PROJECT: DAVID STREET STATION
200 SOUTH DAVID STREET
CASPER, WYOMING 82601

ADDENDUM NUMBER TWO

This addendum number one dated Thursday September 8, 2016 is hereby appended to and became a part of the Contract Documents for the David Street Station, 200 South David Street, Casper, Wyoming. Drawings and specifications dated May 10th, 2016.

L-27a

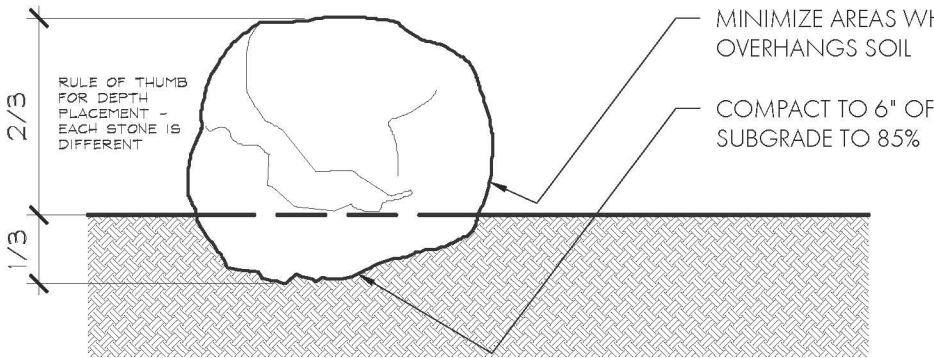
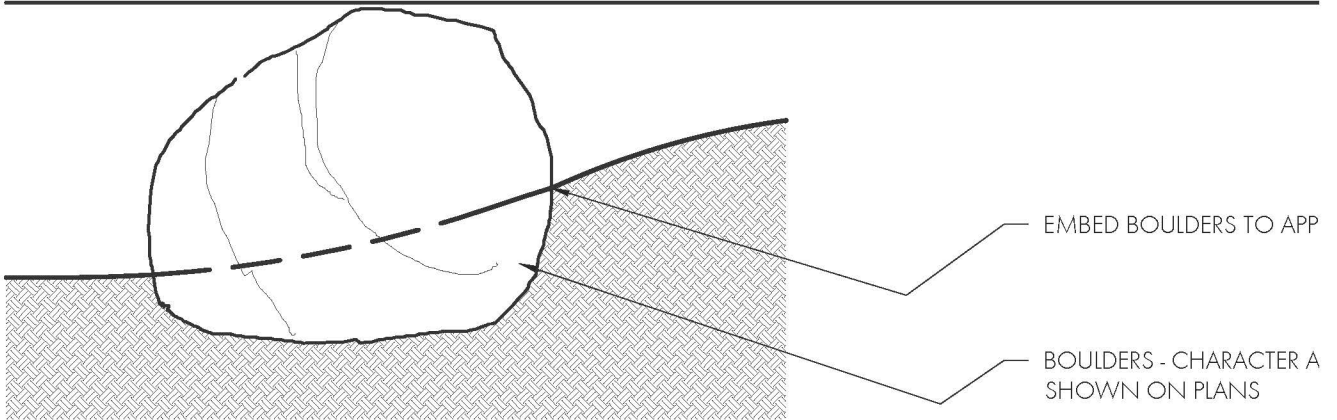
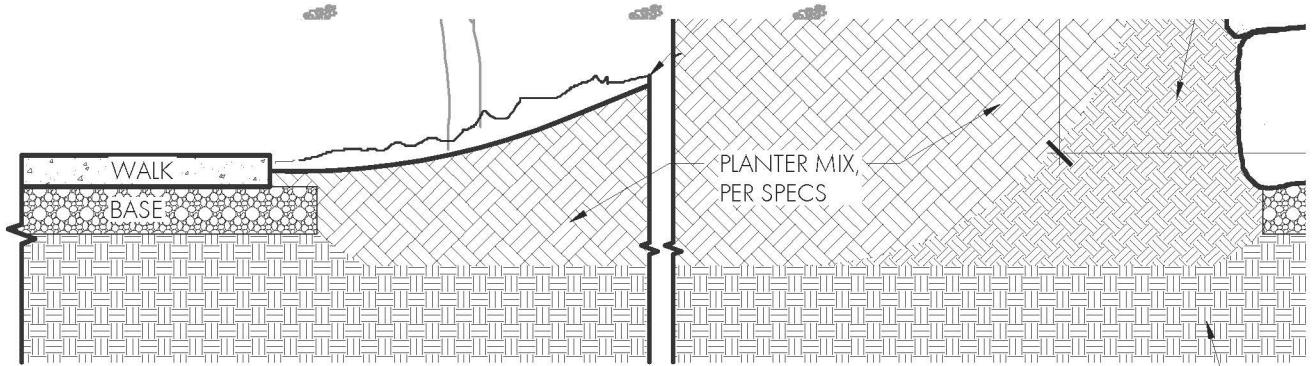
CHANGE: See Sheet L-27a attached. Detail 1 has been renamed "48" Stone Wall". Its location is described in Planter Elevation E on Sheet L-27 and on Sheet L-4.

CHANGE: See Sheet L-27a attached. Detail 4 has been corrected so the lower section is named "Boulders In Landscape". Concrete base below boulders is only required where boulder edges are set in concrete.

L-29a

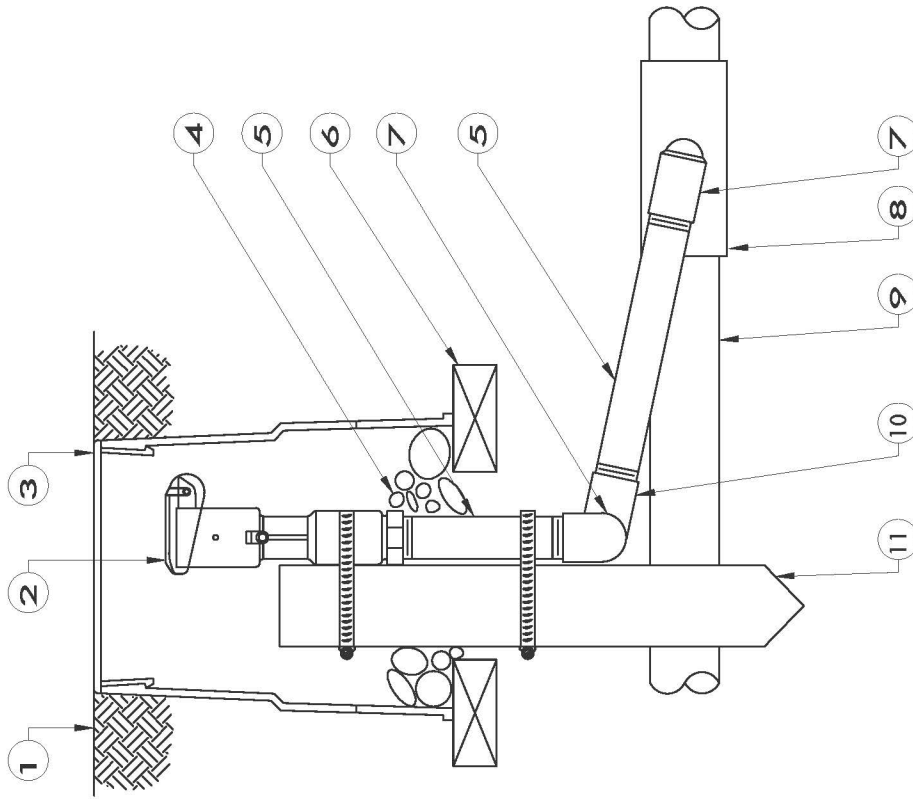
CHANGE: Quick Coupler shall be ¾” Rainbird 33-DLRC ¾” (20/27) Double Track Key Lug, or equal. See revised Detail 9 Sheet L-29a.

1.00

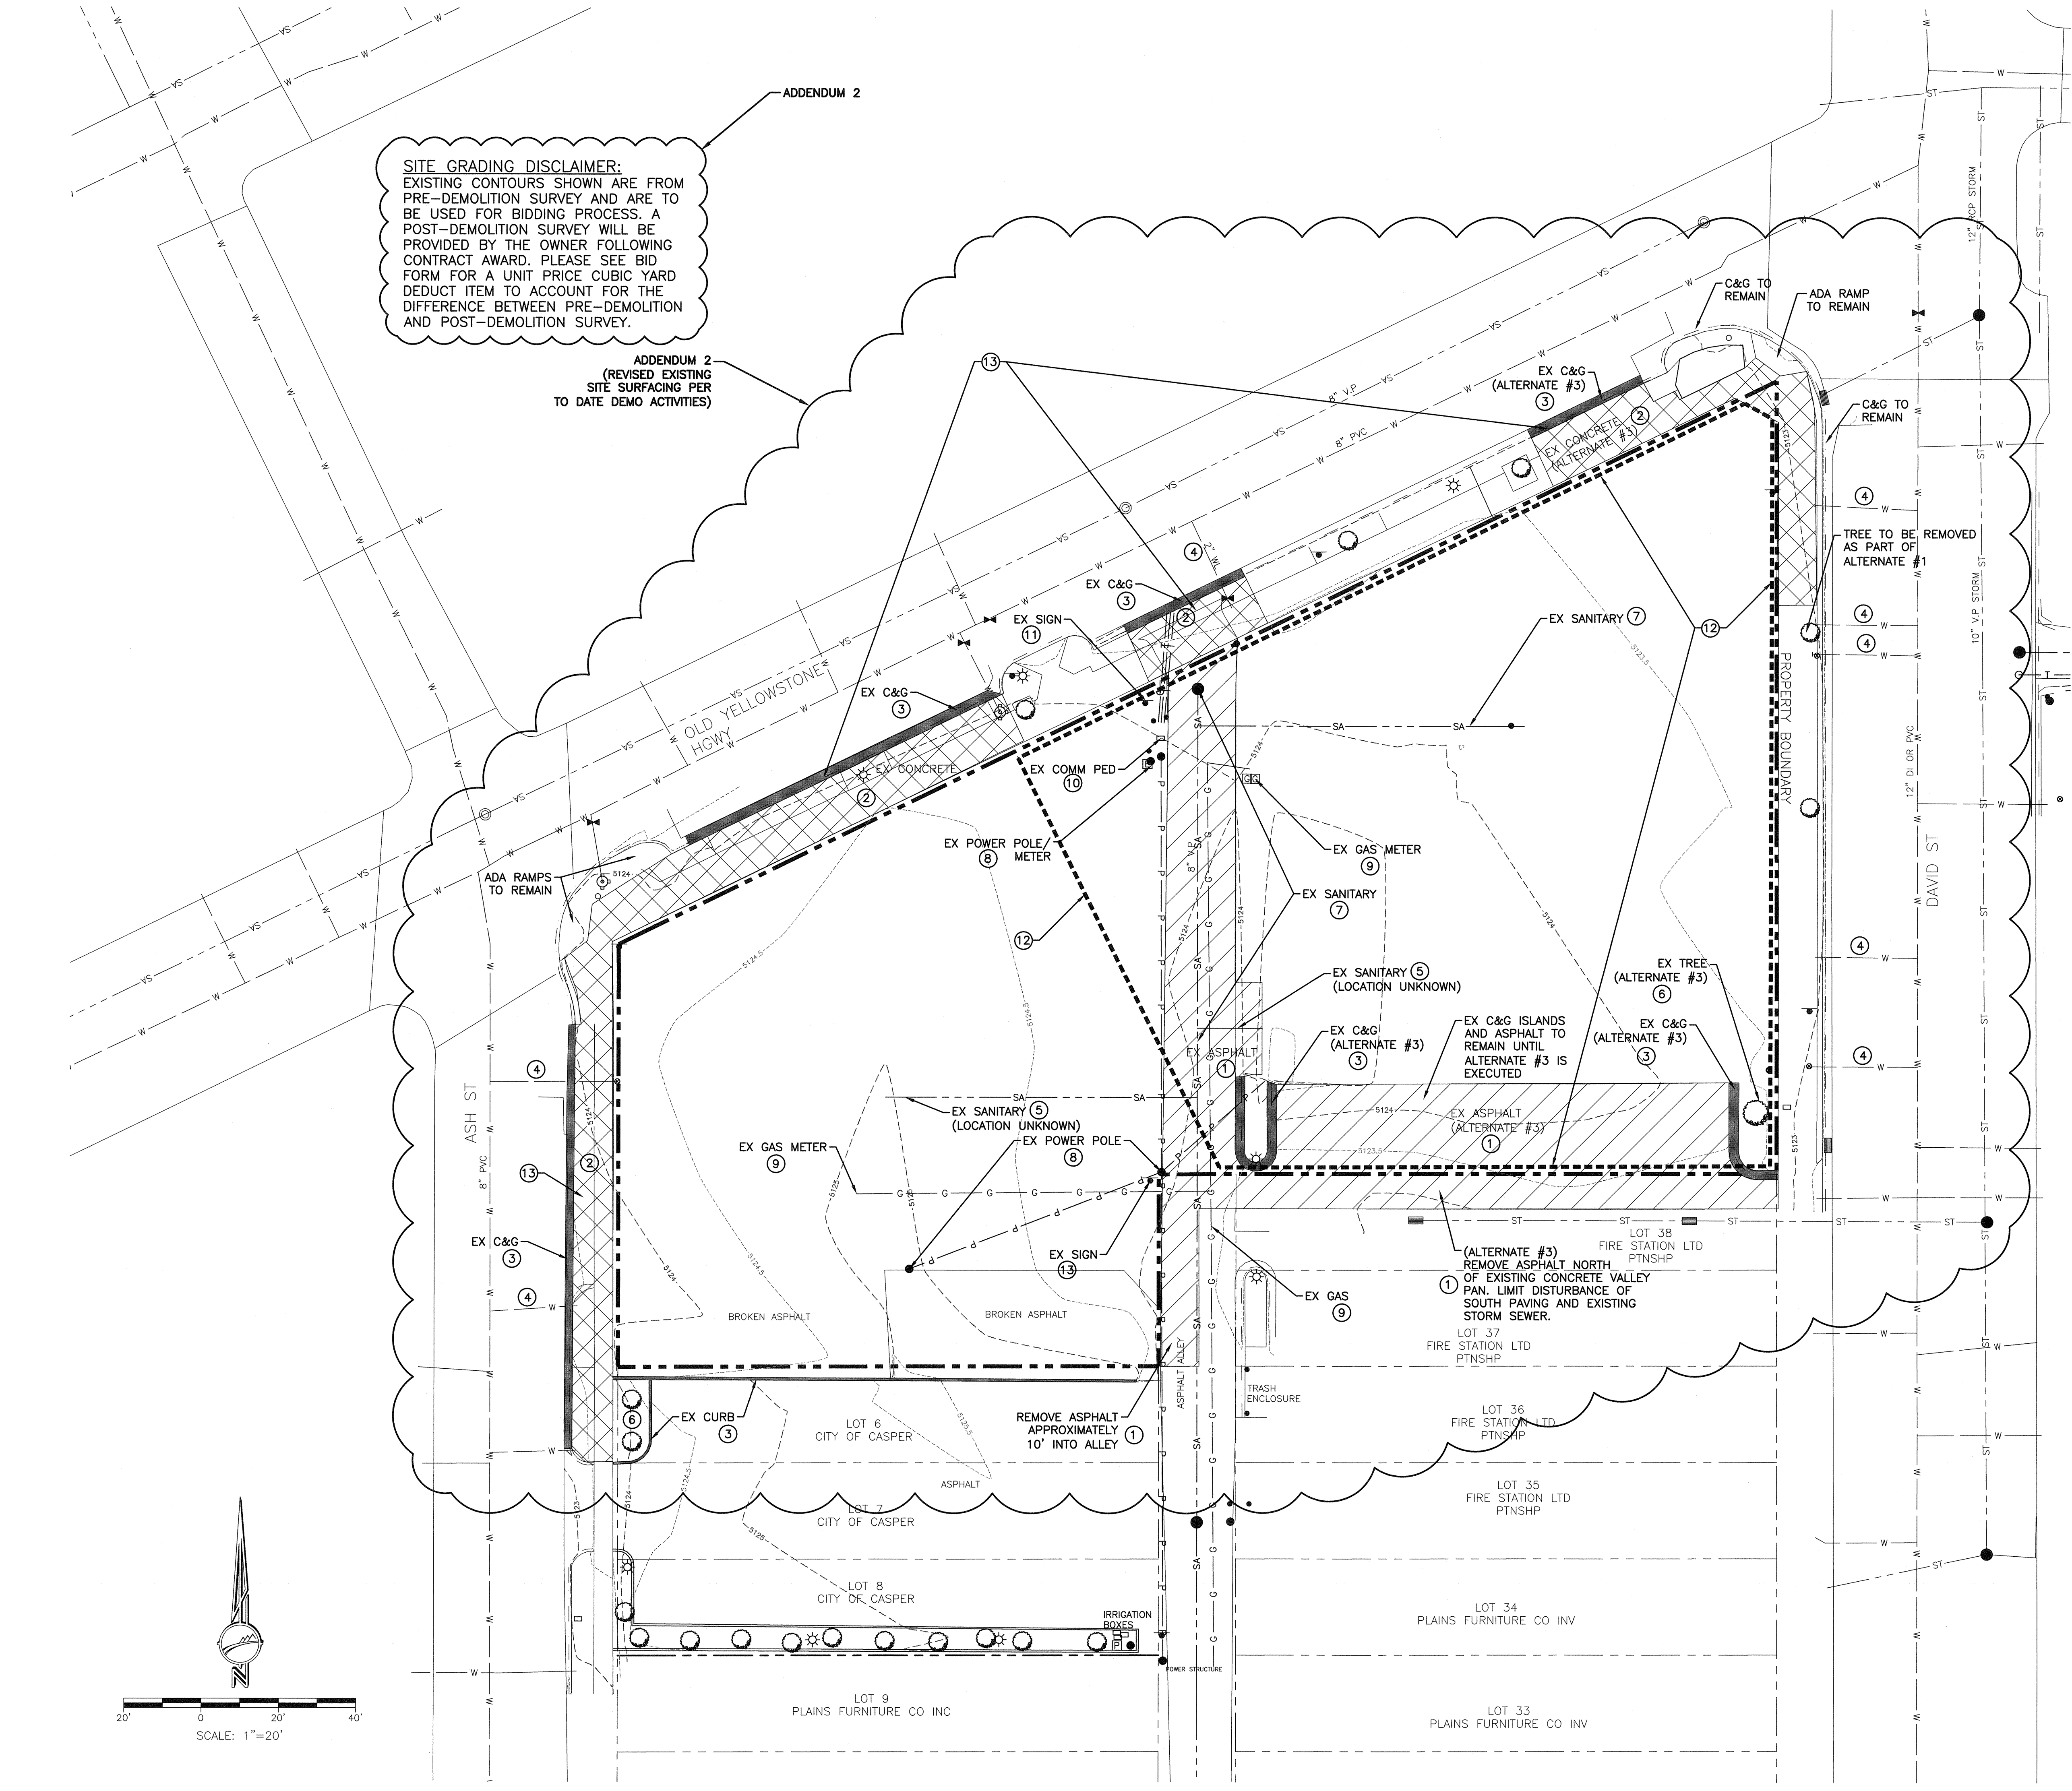
CHANGE: See the clouded areas on the attached Sheet 1.00 for revisions.

1.03

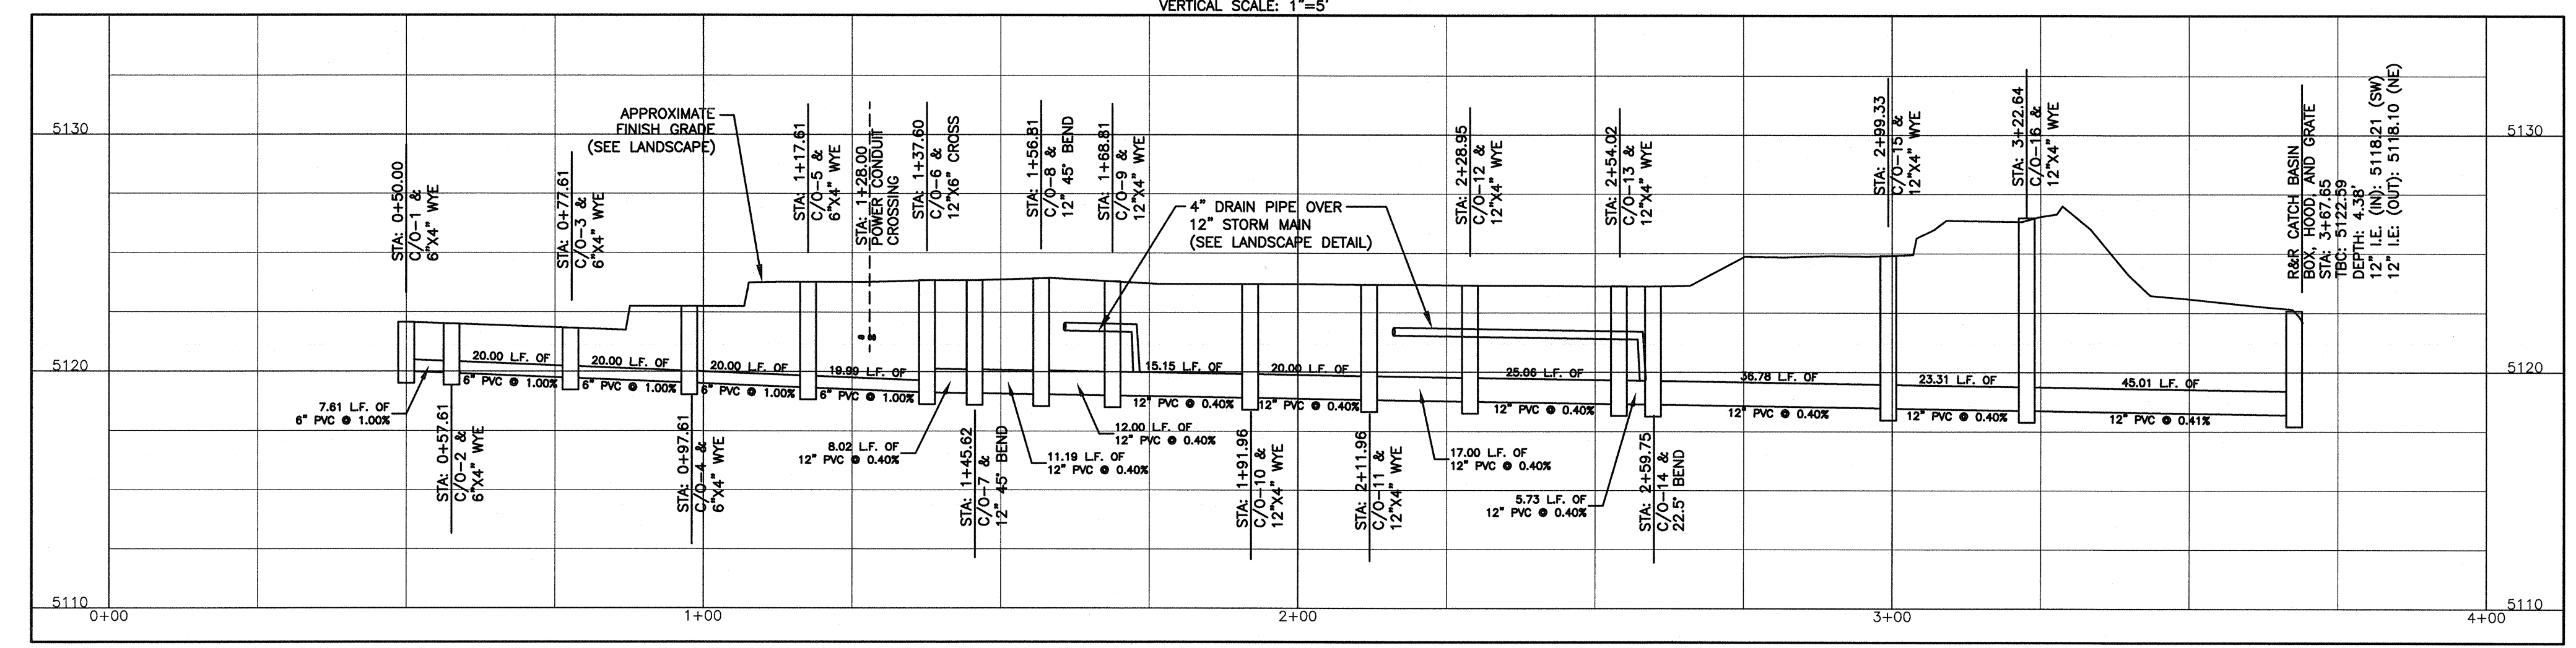
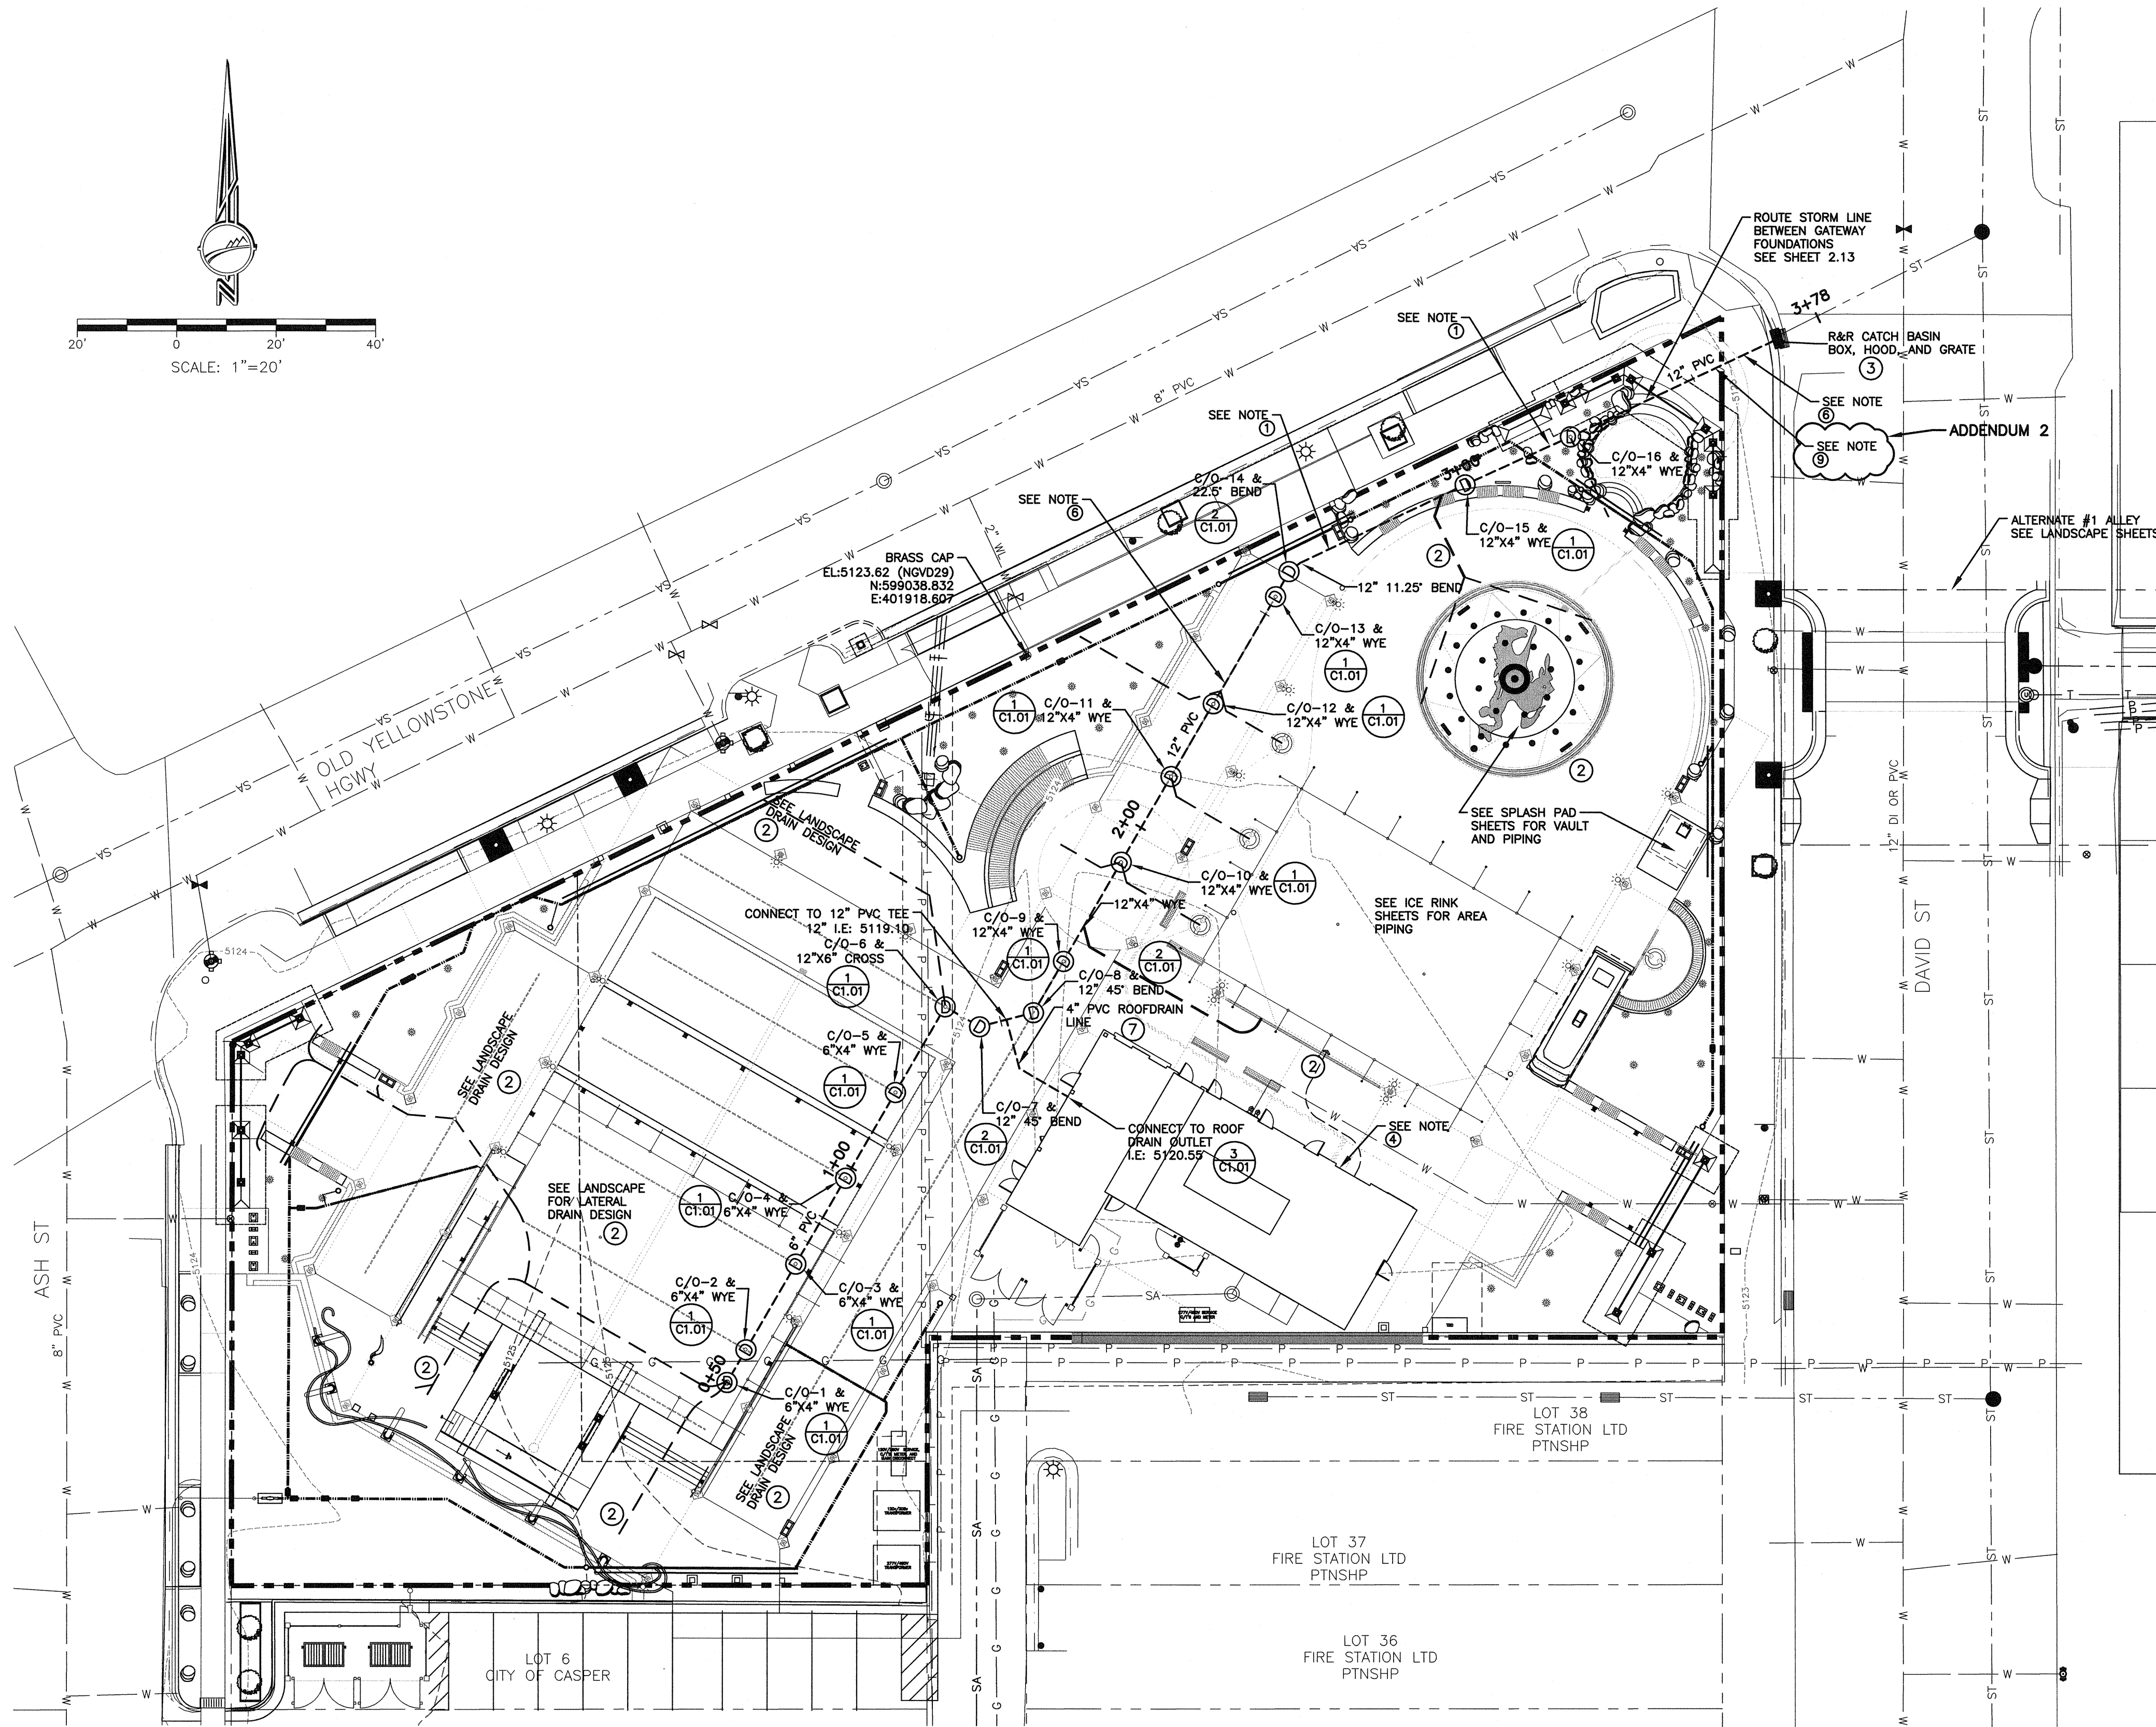
CHANGE: See the clouded areas on the attached Sheet 1.03 for revisions.
